Source: Leece-Neville Heavy Duty Systems Division -
Arcade, NY USA
Date: February 28, 2006
Subject: Replacement of 8RL3021, 8RL3022 with 8RL3024
Bulletin No: TSB-1041
Models: 8RL3021, 8RL3022, 8RL3024

Replacement of 105-351 (8RL3021) and 105-352 (8RL3022) with 105-396 (8RL3024)

Bulletin No.: TSB-1041

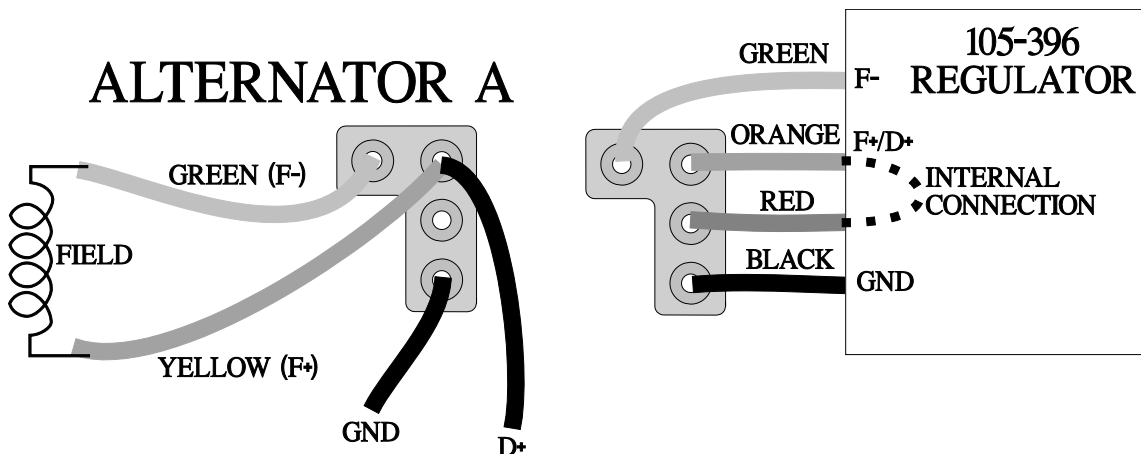
The following alternators (110-302, 110-258A, 110-316, 110-431, 110-569) referred to as **ALTERNATOR A** used a three wire regulator (105-351). The D+ signal is connected directly to the positive side of the field (F+) inside the alternator. In this configuration, the red lead from the 105-396 regulator is not used and is connected to an unused terminal.

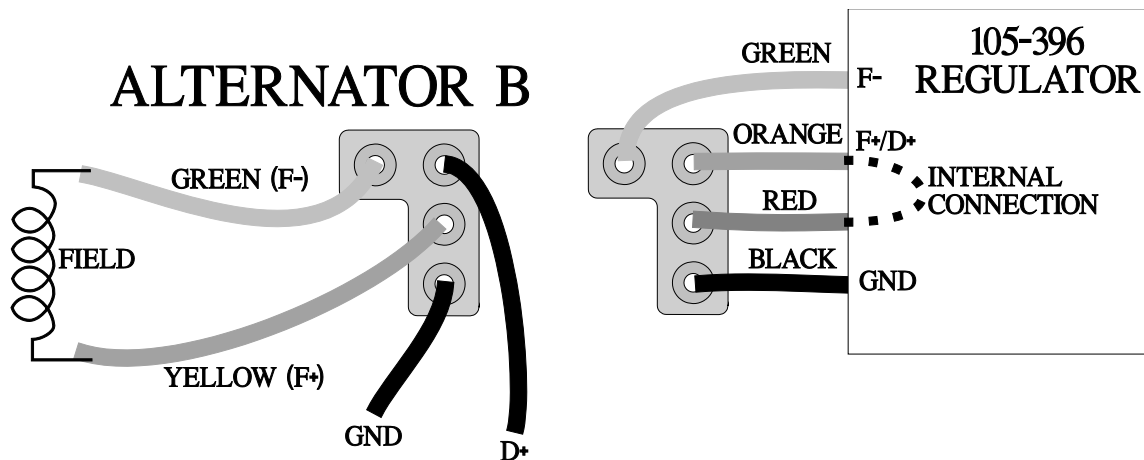
This alternator (110-298) referred to as **ALTERNATOR B** originally utilized the four wire regulator (105-352). The internal wiring of this alternator and regulator has not changed.

When installing the new regulator, use the following torques:

Terminal nuts (4)	4-7	in. lb.
Mounting screws (4)	28-33	in. lb.
Excitation nut (1)	25-30	in. lb.
